Lower Thames Crossing
9.69 Draft Statement of
Common Ground between (1)
National Highways and (2)
Harlex Haulage and (3) J & B
Martin (Crayford & Fawkham)
Limited
(Tracked changes version)

Planning Inspectorate Scheme Ref: TR010032
Examination Document Ref: TR010032/EXAM/9.69

Table 2.1 Matters

Appendix B Harlex Vehicle Tracking

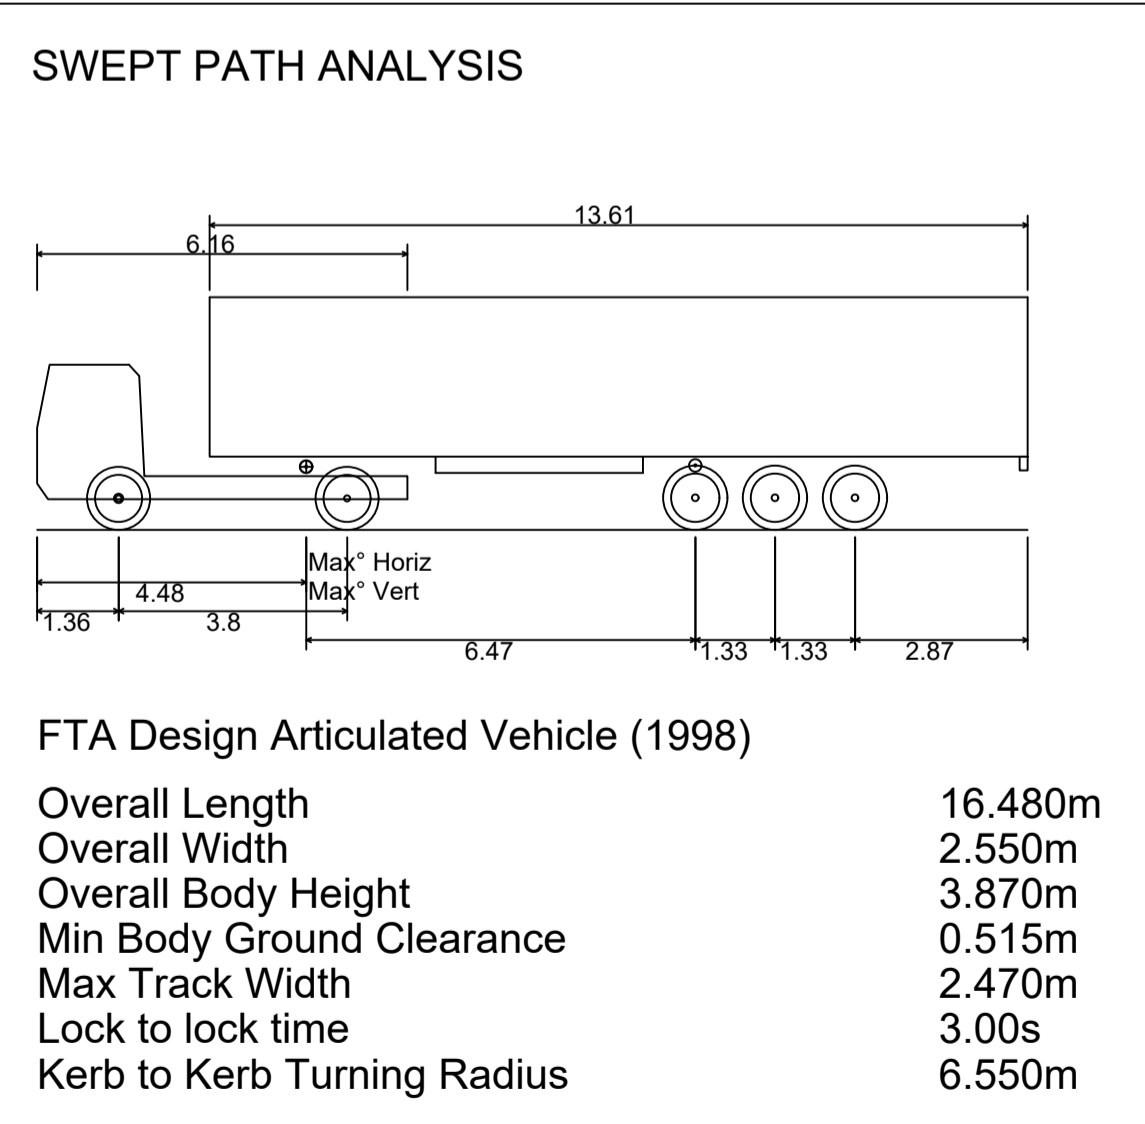
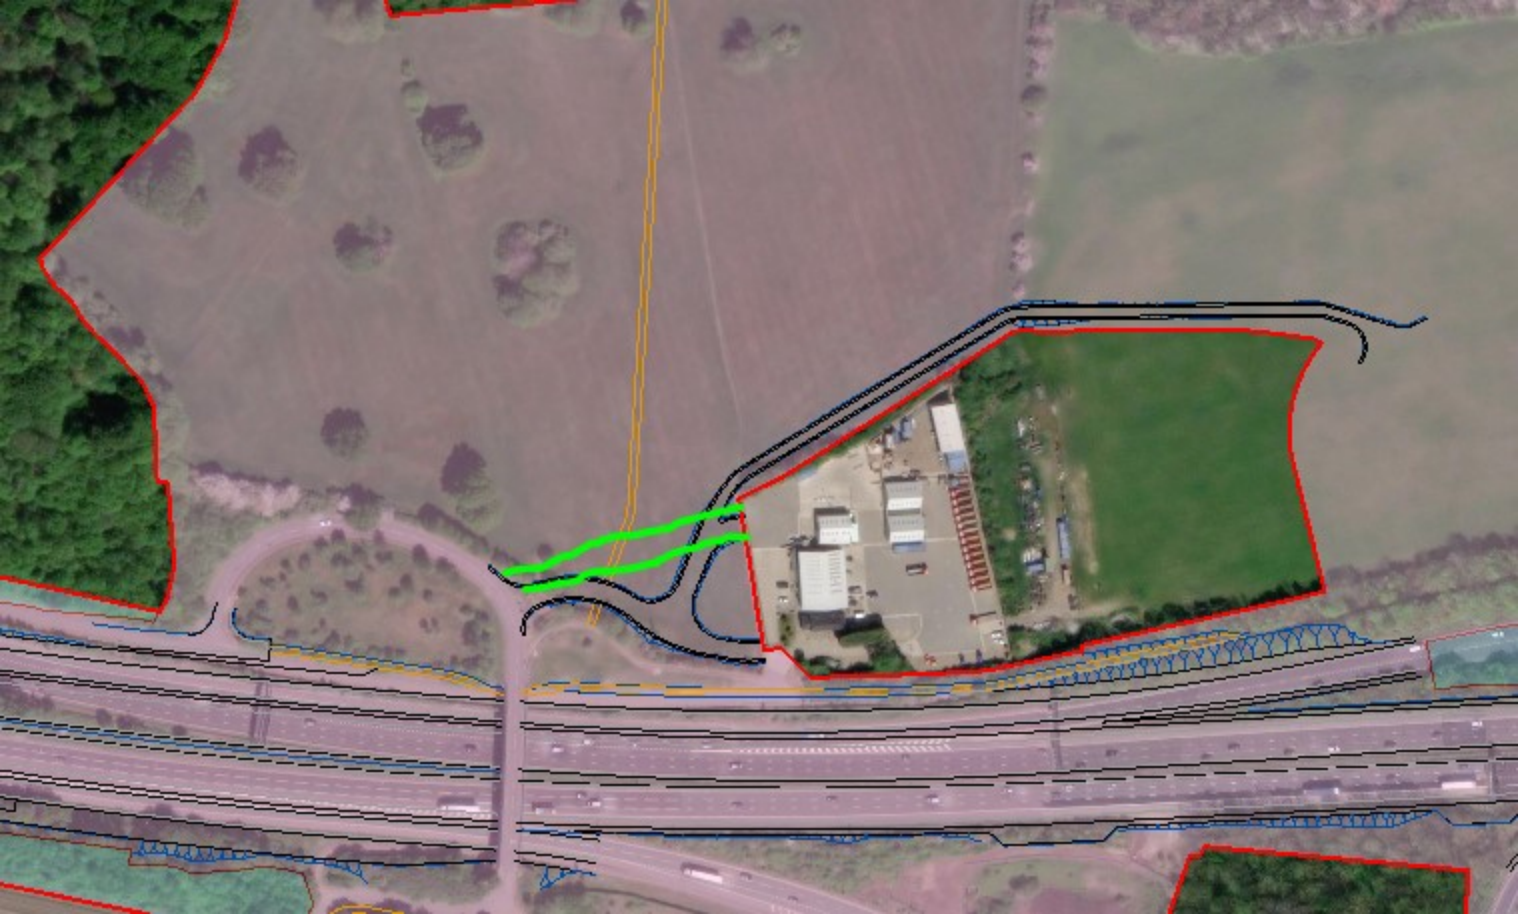
Replacement Access Updated Entrance & Exit Design Request	2.1.3	Harlex propose a new updated entrance and exit design for the replacement access. <u>The reason for this request was that there was no alternative and that the Applicant had not appreciated the design requirements during early design.</u> <u>The interested party remains sceptical the sweep paths and vehicle tracking will work</u>	The current design (Work No 1C as shown on Sheet 3 of the Works Plans) was proposed by Harlex and accommodated by the Applicant at Community Impacts Consultation (June 2021). The Applicant has undertaken vehicle tracking and shared the same demonstrating articulated vehicles measuring 15.5m in length, can navigate	<u>Works Plans Volume B Composite [REP4-038]</u>	Matter Not Agreed

Topic	Item No.	Harlex Haulage Limited, and J & B Martin (Crayford & Fawkham) Limited Comment	The Applicant's Response	Application Document Reference	Status
		<p><u>in practice from Park Pale Road and into the haulage yard</u></p>	<p>the replacement access in its current design. Please refer to Appendix 1. This further request to change the design, as illustrated in Appendix 2, received on 7 February 2023, will have many impacts and the Applicant has a number of design concerns over the design of the access proposed by Harlex. Splitting the carriageway until the junction will lead to vehicles entering and exiting the junction on the wrong side of the road (as Harlex switch their direction of one way operation), which would be a safety risk. The current design ensures that all vehicles are on the correct side of the carriageway at the junction. As the access will also be used by the Applicant for maintenance of ponds, it would also mean that maintenance vehicles would either have to travel against the flow of traffic or go through the Harlex site to avoid conflict. Splitting the carriageway also means pedestrians using the footpath will have to cross two carriageways, which is avoided in the current proposal. It may also need to be consulted on and will incur additional cost (compared to current design) and introduce consultation uncertainty.</p>

Topic	Item No.	Harlex Haulage Limited, and J & B Martin (Crayford & Fawkham) Limited Comment	The Applicant's Response	Application Document Reference	Status
			<p><u>The replacement access to Harlex Haulage is a private/maintenance access track; therefore, it does not fall under the requirements of the Design Manual for Roads and Bridges (DMRB). However, to promote a conservative design approach at this stage of preliminary design, DMRB CD 123 recommendation at clause 5.2 has been considered: "Allowance shall be made for the swept turning paths of the worst case design vehicle which is expected to use the priority junction."</u></p> <p><u>The worst case scenario was not available at the time of the design; therefore, a standard design vehicle has been used in accordance with DMRB CD 123, which states: "The design vehicle for at-grade priority and signal controlled junctions is a 16.5m long articulated Heavy Goods Vehicle."</u></p> <p><u>As noted under clause 5.6.2 in DMRB CD 123: "At simple priority junctions where provision is made for the design vehicle, the corner radii should be 15 metres in</u></p>

Topic	Item No.	Harlex Haulage Limited, and J & B Martin (Crayford & Fawkham) Limited Comment	The Applicant's Response	Application Document Reference	Status
			<p><u>rural areas followed by a corner taper of 1:10 over a distance of 25 metres.</u></p> <p>The uses of this junction will be limited to Harlex Haulage and National Highways maintenance vehicles only. Members of the public and general road users should not be using this access; therefore, this is a private means of access. As this junction does not sit on the Strategic Road Network nor form a through route the design has been developed to safely fit within the surrounding constraints.</p> <p>With all the considerations above, it is therefore concluded that the design of the access to Harlex is safe and in line with good practice and current standards.</p>		
Replacement Access – Tie in works	2.1.4	<p>Harlex suggest there would be level issues with ensuring the new access ties into the site</p> <p><u>The previous draft proposals provided by the Applicant need to be updated and take account of the further meetings held since April 2021.</u></p>	<p>The Applicant's design accommodation letter for the replacement access road specifically deals with this issue and mitigates disruption. This was issued on 1 April 2021 with subsequent reminders. The Applicant will update and recirculate the design accommodation letter for the landowner to sign and return, so it can transfer the commitments therein to Contractors and an associated Project Manager lead to ensure compliance.</p>	N/A	Matter Under Discussion
